Lone Tree City Council Agenda Tuesday, March 4, 2014

Project Type / #: Site Improvement Plan (SIP), Project #SP13-52R

SUBJECT: RidgeGate Section 15, Filing 11, 2nd Amendment
Site Improvement Plan (Commonwealth Heights), Project #SP13-52R

Sight Improvement Plan

EXISTING

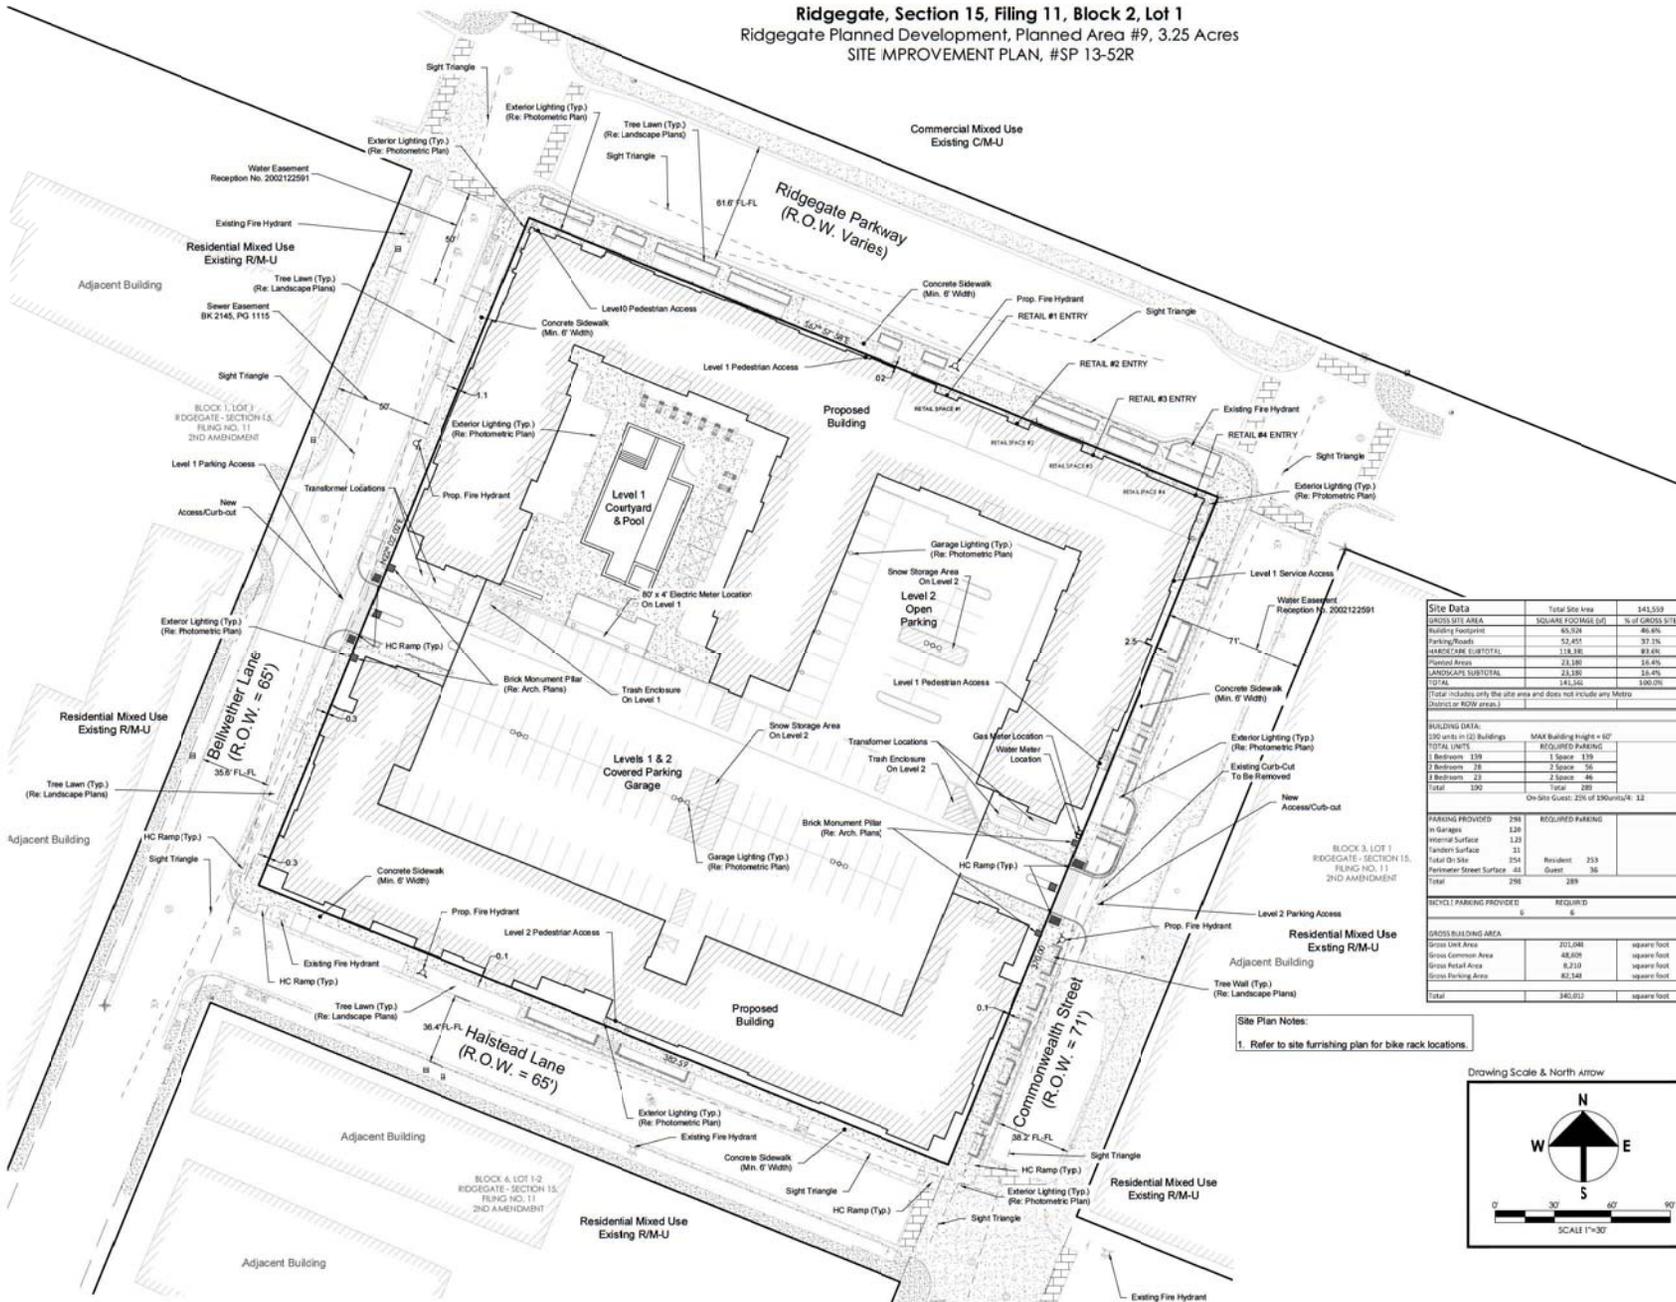
PSCo also requests that the gas pipeline be shown on the Existing Conditions Plan Sheet C1-0.

Sht. C2-0 (3 of 34) – Site Plan

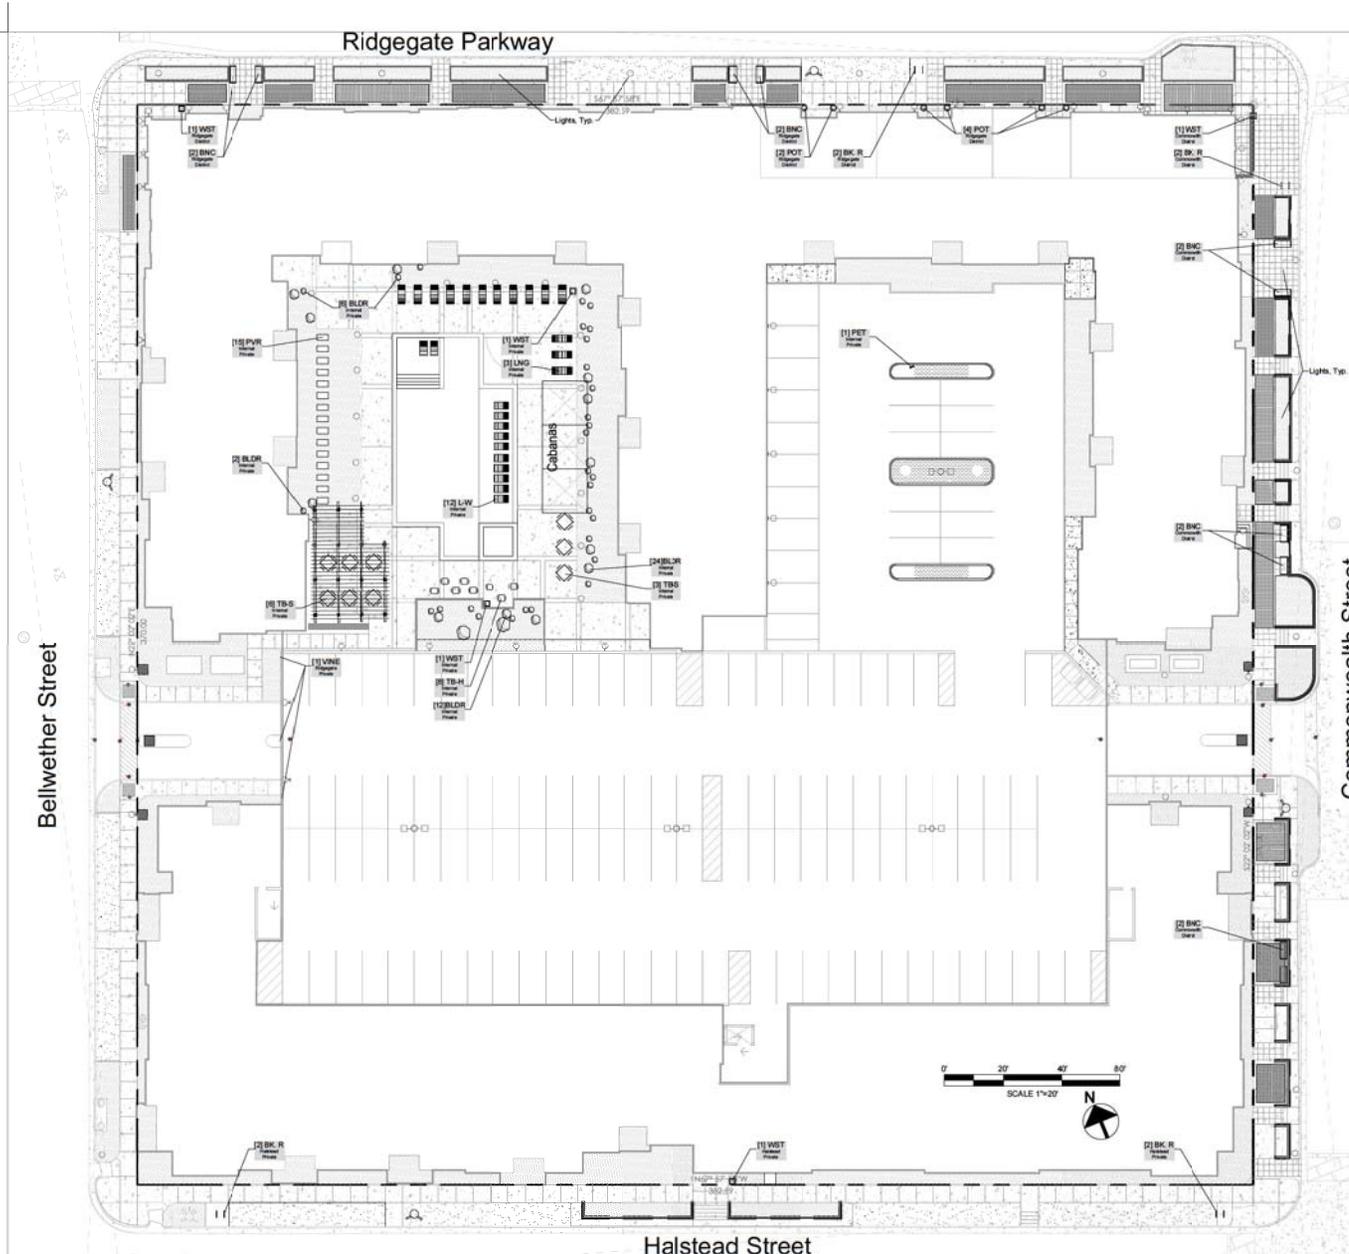
4. A number of non-standard landscaping features are proposed within the ROW (such as Tree Walls in Commonwealth Street and Halstead Lane ROW’s, and what appears to be curbed or walled planter areas in RidgeGate Parkway ROW). Additionally, based on the limited set-back of the building from the lot line/ROW line, there also may be some encroachments across the ROW line from building overhangs/attachments (such as entry awnings etc.). The ROW line should be clearly shown on all sheets, and any such proposed “building encroachments” should be identified. An appropriate License Agreement addressing the non-standard planters/walls and any building encroachments in the ROW will need to be developed and executed between the Owner/Developer and the City, prior to final engineering approvals and final SIP approval.

Overall Site
 Landscape Plan
L2-0
 8 of 24

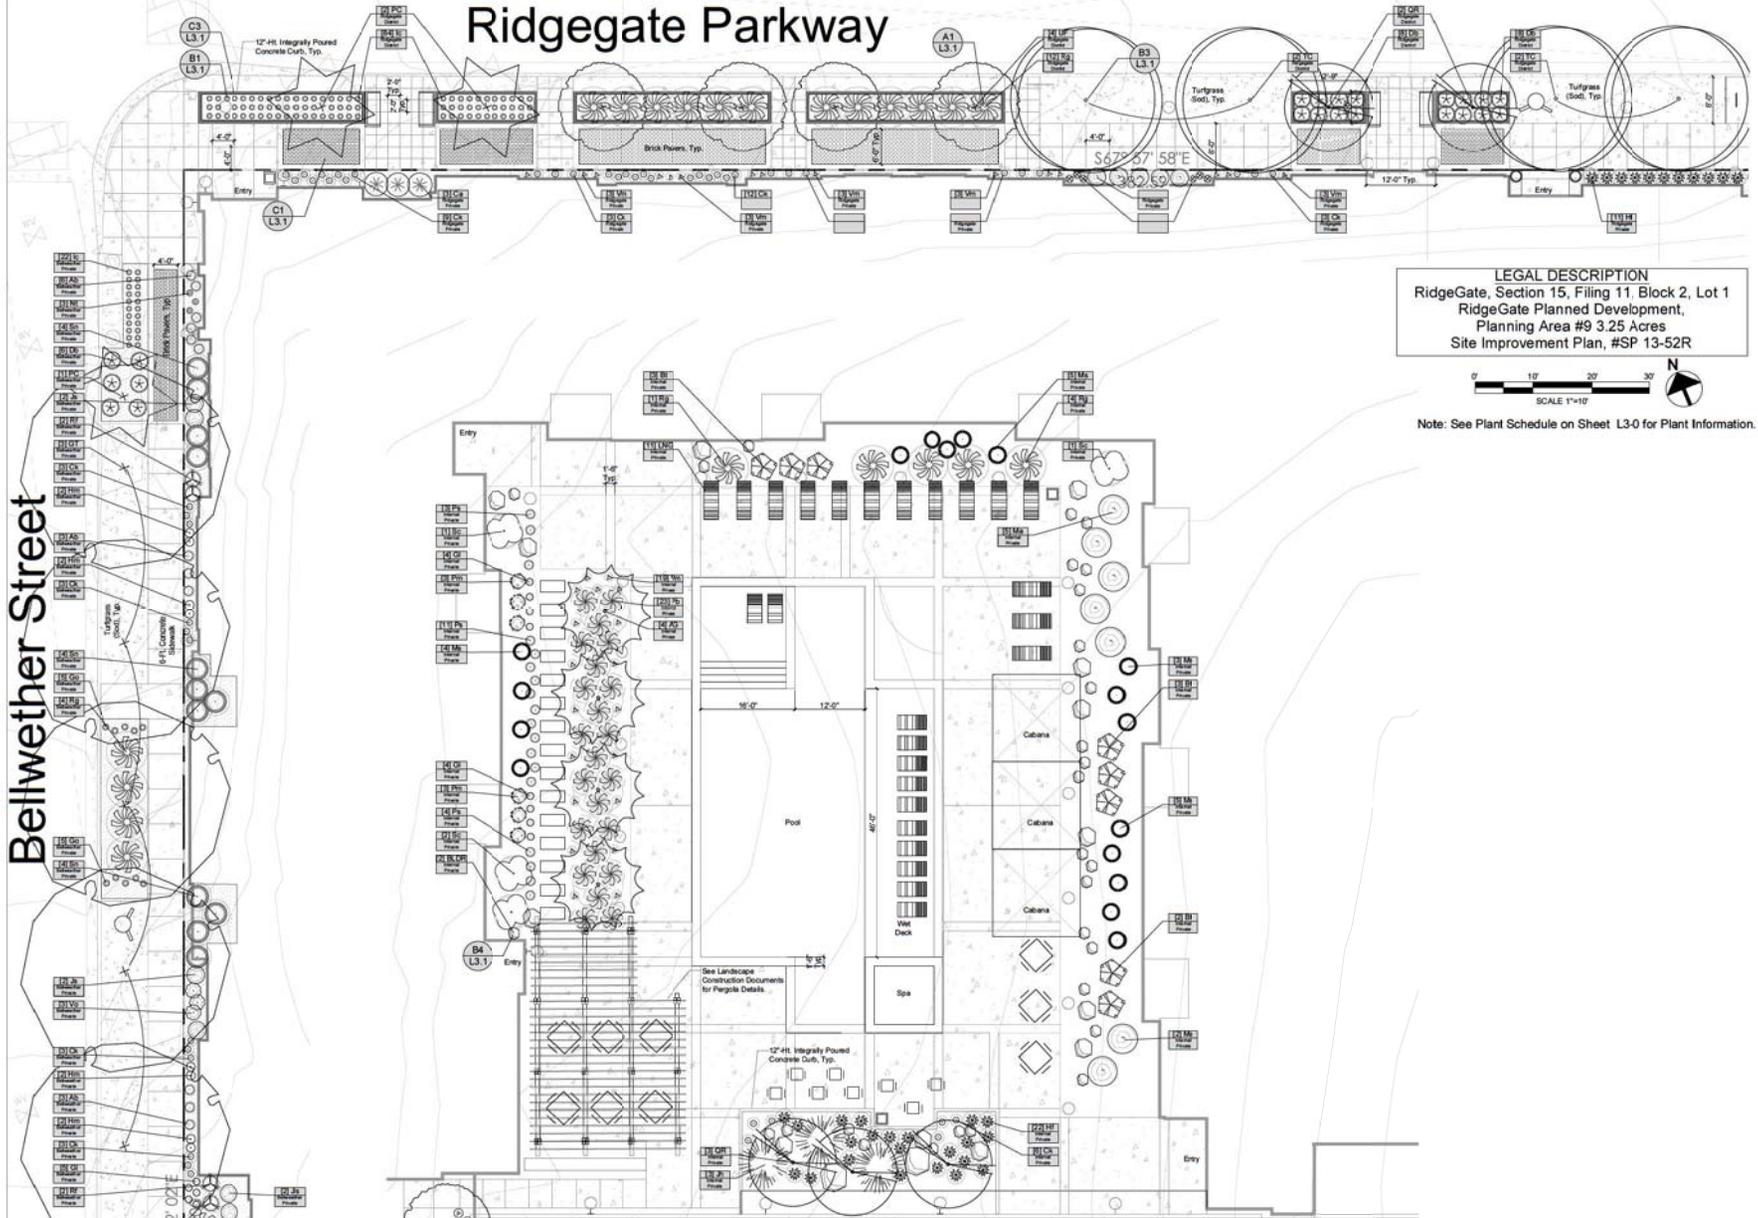
7. Pedestrian style lighting is shown along the RidgeGate Parkway and Commonwealth Street frontage. Some of the landscaping/trees shown on this sheet appear to conflict with some of the proposed pedestrian lighting locations. While this apparent conflict may be a graphic scale issue rather than an actual conflict, the Developer/applicant should make necessary adjustments to avoid potential conflicts.
8. The following notes should be added regarding the landscaping:
 - a. Tree branches extending beyond the flow line of the adjacent curb and gutter and/or beyond the edge of the adjacent sidewalk shall maintain a height at or above 7’ measured from the adjacent flow line and/or sidewalk (as applicable).
 - b. The City of Lone shall not be liable for damage to trees within the ROW caused by snow removal or maintenance equipment due to conflicts with overhanging branches that are too low.

- c. Objects within the required sight triangles, including, but not limited to landscape planters and landscaping, shall be in compliance with the sight triangle standards in the City adopted Douglas County Sight Roadway Design and Construction Standards (re: Section 4.11.4 – Intersection and Driveway Sight Distance).

SHEET 20 OF 24
SITE
PHOTOMETRIC
PLAN

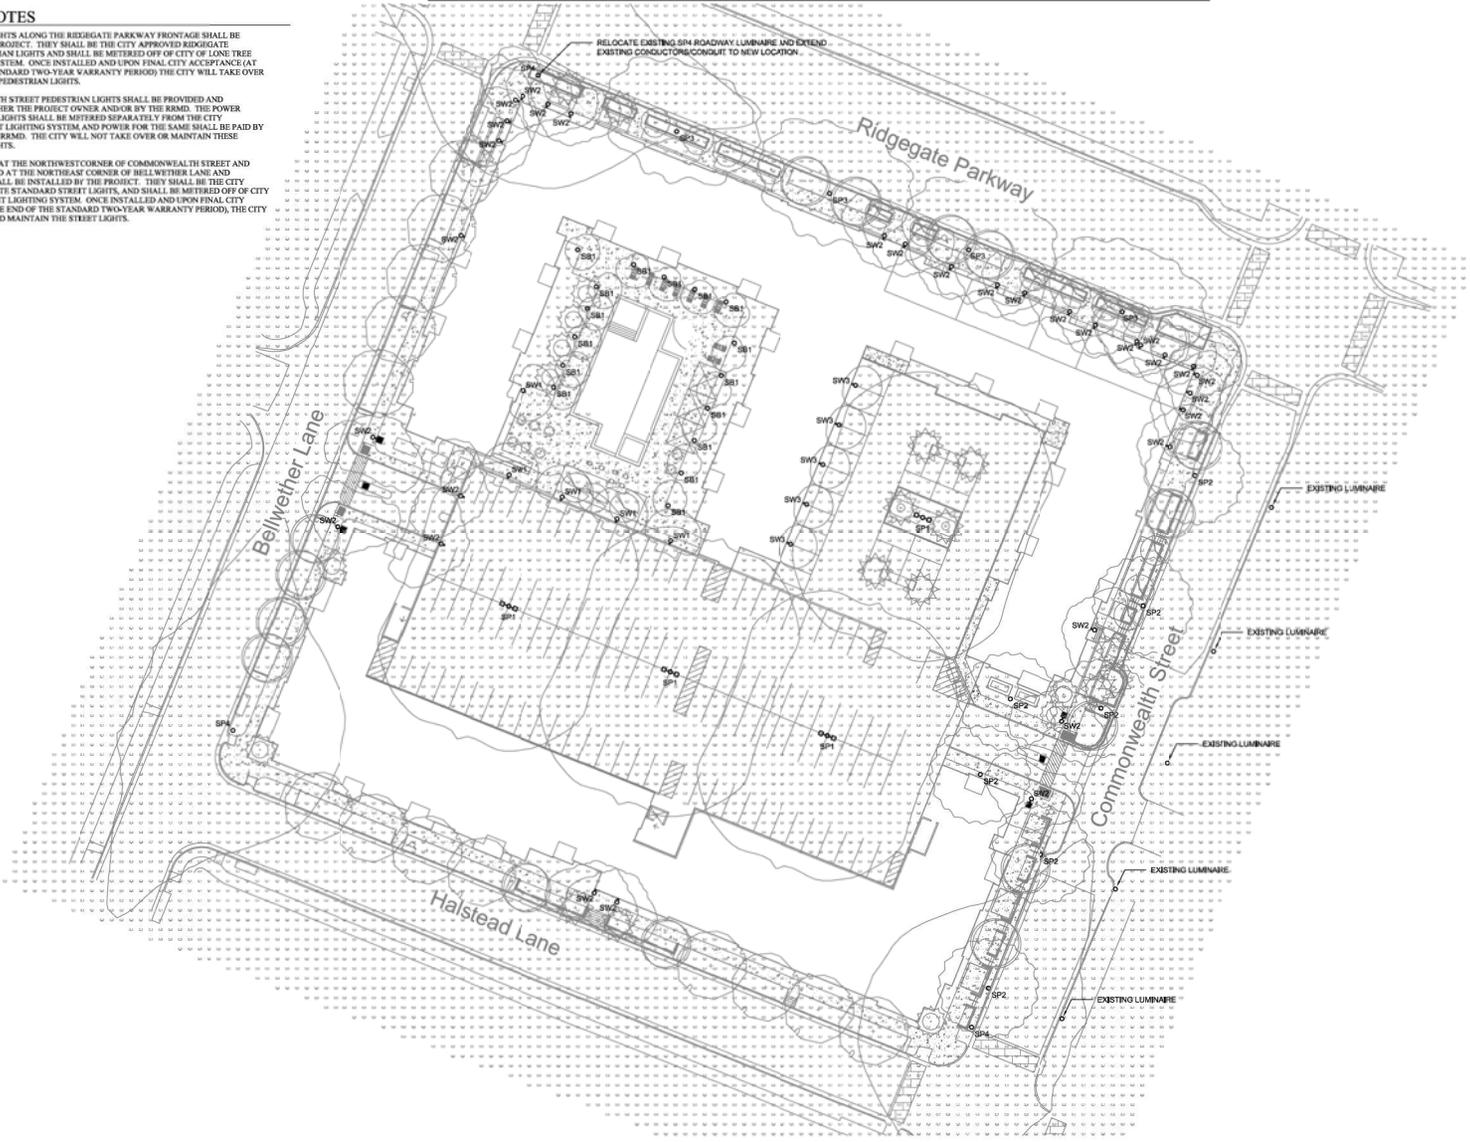
10. The proposed street/pedestrian lighting plan along RidgeGate Parkway should be revised to conform to the following to provide better consistency/continuity with the existing lighting on RidgeGate Parkway at the adjacent Miramont at RidgeGate development:

- b. The pedestrian lights shall conform to the adopted RidgeGate Standard – as identified within the City adopted RidgeGate Roadway Standard and Guidelines (July 10, 2003, Revised August 29, 2007).

11. The Developer/RRMD and City Planning should review the proposed Type SP2 lighting plan along the west side of Commonwealth Street between RidgeGate Parkway and Halstead Lane in regards to consistency (or lack thereof) with the similar lighting already installed along the east side in this block. The light fixture style appears similar, however the spacing and location of the lights is not similar. On the east side, there are five (5) lights, spaced from 60'-80' (nominally 75') apart, while on the west side a total of 7 SP2 and 2 SW2 lights are proposed, at spacing of 28'-55' (nominally 45'). It might be desirable to consider more closely match the light location/spacing on both sides of the street for uniformity. For consistency, the Type SP2 light should be specified as the single head fixture style (re: Sheet E1-3, SP2 details).

13. The following notes should be added regarding the pedestrian and street lighting:
 - a. The pedestrian lights along the RidgeGate Parkway frontage shall be installed by the Project. They shall be the City approved RidgeGate Standard pedestrian lights, and shall be metered off of City of Lone Tree street lighting system. Once installed and upon final City acceptance (at the end of the standard two-year warranty period) the City will take over and maintain the pedestrian lights.

1. THE PEDESTRIAN LIGHTS ALONG THE RIDGEGATE PARKWAY FRONTAGE SHALL BE INSTALLED BY THE PROJECT. THEY SHALL BE THE CITY APPROVED RIDGEGATE STANDARD PEDESTRIAN LIGHTS AND SHALL BE MITERED OFF BY CITY OF LONG TREE STREET LIGHTING SYSTEM. ONCE INSTALLED AND UPON FINAL CITY ACCEPTANCE (AT THE END OF THE STANDARD TWO-YEAR WARRANTY PERIOD) THE CITY WILL TAKE OVER AND MAINTAIN THE PEDESTRIAN LIGHTS.

2. THE COMMONWEALTH STREET PEDESTRIAN LIGHTS SHALL BE PROVIDED AND MAINTAINED BY EITHER THE PROJECT OWNER AND/OR BY THE RMD. THE POWER SOURCE FOR THESE LIGHTS SHALL BE MITERED SEPARATELY FROM THE CITY CONTROLLED STREET LIGHTING SYSTEM AND POWER FOR THE SAME SHALL BE PAID BY THE OWNER AND/OR RMD. THE CITY WILL NOT TAKE OVER OR MAINTAIN THESE NON-STANDARD LIGHTS.
